**PPPL ENGINEERING CHANGE NOTICE (ECN) ECN # 5140R4**

**ECN TITLE: Changes to Modular Coil Lead Area Design**

**AREA OR PROJECT: NCSX**

Figure 1

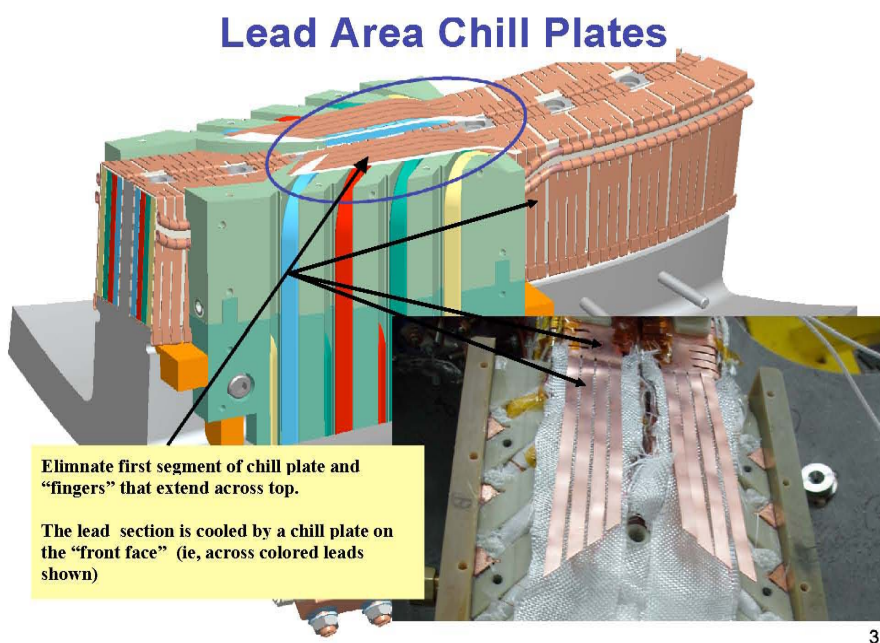
- On the top chill plate (the one with the long fingers that extend parallel to the coil) – cut off the fingers and eliminate the chill plate. **(See Figure 1).** *This change will be implemented for the C3 and follow-on coils.*

Figure 2

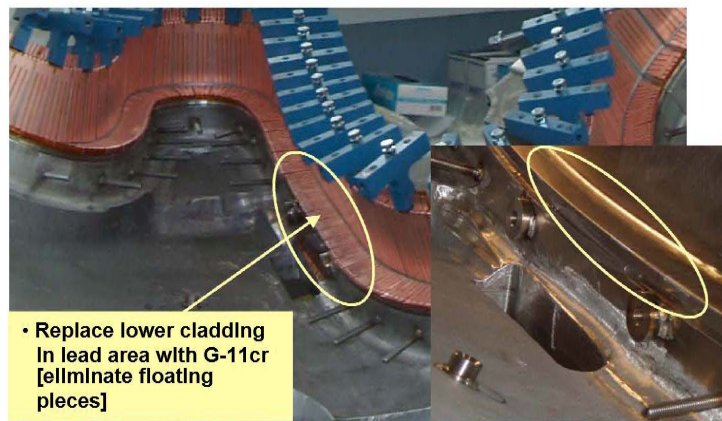
- Isolated copper cladding pieces (located on the base of the tee underneath the winding pack in the lead area, the vertical cladding pieces in the same area, and the cladding in the poloidal break area) – change the material to G-11cr. **(See Figure 2).** *This change will be implemented starting with the C5 and follow-on coils.* Note: The G-11 pieces should be made to look like the cladding (with slots) so that forming to the shape and wicking of epoxy will be that same as for other areas.

Figure 3

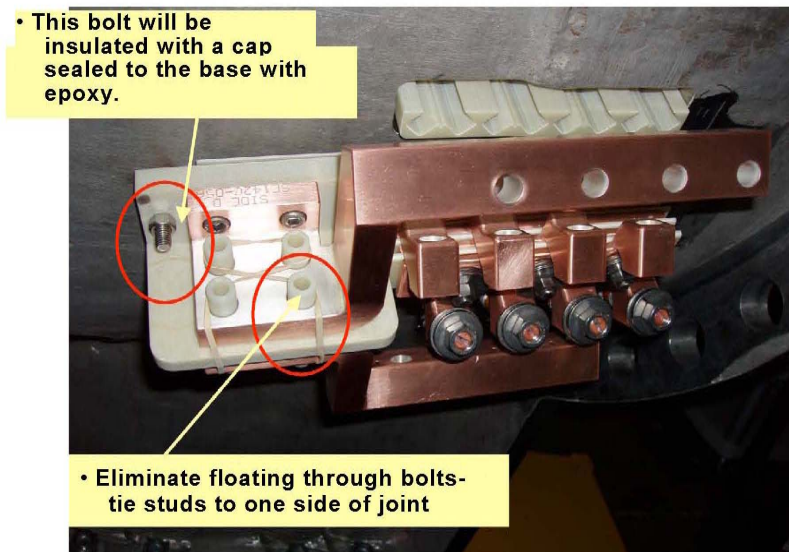
- For the power bus tie-in area, install Kapton sheet over attachment bolt ~~cap the attachment bolt with an epoxy seal~~ to mitigate a potentially short tracking path. **(See Figure 3L).** *This will be implemented on all coils.*

- Presently the four bolts that connect the power bus are floating which is an undesirable condition **(See Figure 3R )** - connect them to one side by eliminating the insulating washers on the other side. *This will be implemented on all coils.*

Figure 4

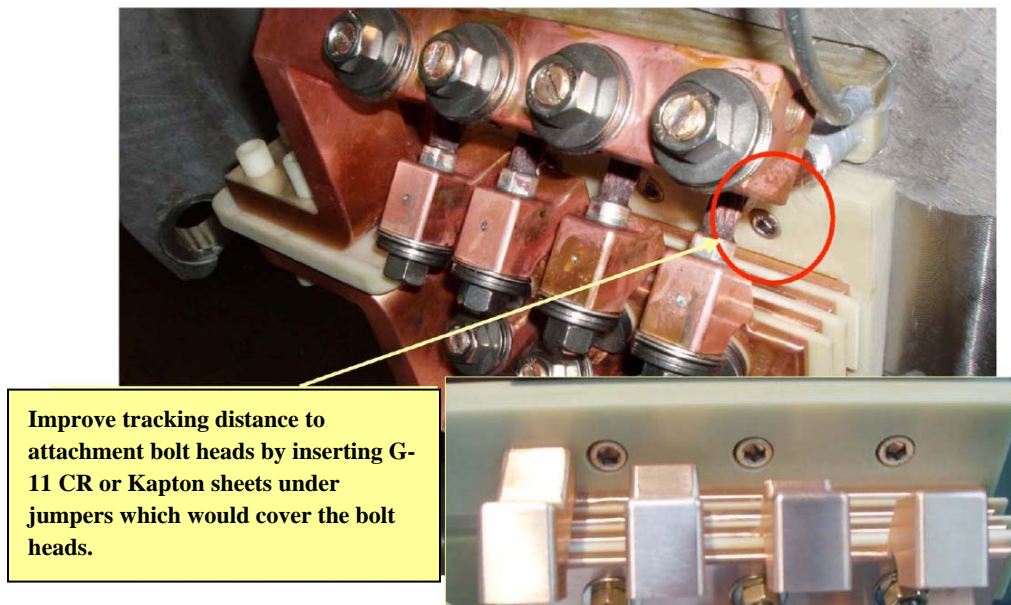
- The bolts that attach the G-11 base plate underneath the jumper stack – put a cover (Kapton or thin G-11 sheet) to increase the tracking distance. **(See Figure 4).** *This will be implemented on all coils.*
